### **Submission regarding works approval application for “The Barracks” development, Canberra**

The Lake Burley Griffin Guardians appreciate the opportunity to make a public submission on the works approval application by the Morris Property Group for the development known as “The Barracks” on Section 100 (formerly Block 19 Section 63) Canberra.

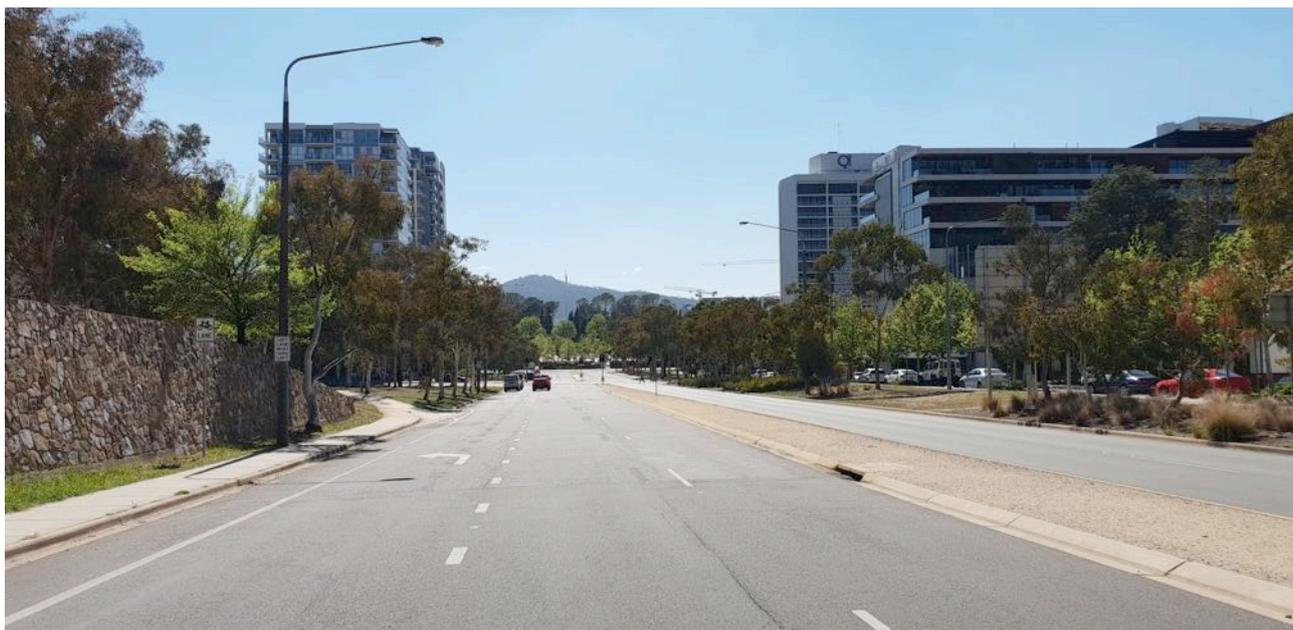
- Over densification of Site 1. The developer appears to have proposed the maximum scale, height and density of development which is permitted for the site. By maximising the private built environment, the proposal extends the concrete jungle of overshadowed footpaths and windswept laneways in City West.

- Lack of pedestrian thoroughfares across the site, between London Circuit and Vernon Circle. By maximising the building footprint, the opportunity for a sense of shared public-private realm internal to the site, as demonstrated in New Acton, does not exist. This is a lost opportunity for a precinct-scale development on this site.

- The Barracks proposal gives an impenetrable terrace frontage onto City Hill that does not interact with that open space in a positive way. This frontage could be colonnaded with shops, hotel and public spaces to give an attractive and vibrant interaction with City Hill. It could also have a mall to invite pedestrians through to the central landscape area of The Barracks and other routes through to London circuit.

- Liveability in the row of loft apartments facing Vernon Circle will be affected by noise, vibration and air pollution from north-bound traffic across Commonwealth Avenue Bridge and also from Edinburgh Ave. The development assumes that the ACT Government's proposed eventual diversion of through traffic onto London Circuit will work. A hotel-style development on Vernon Circle with a formal entrance and vehicle lay-by would be more suited to the eastern side of the site.

- The Knowles Place extension, which is to be used as the main access for 300 apartments and public parking in Stage 1 and the access backbone of the final development, will be a noisy congested service lane (see the traffic management study in the works approval application).

- All car parking should be underground, not a mix including above ground internal parking as proposed, which has the effect of industrialising the façade above the ground floor.
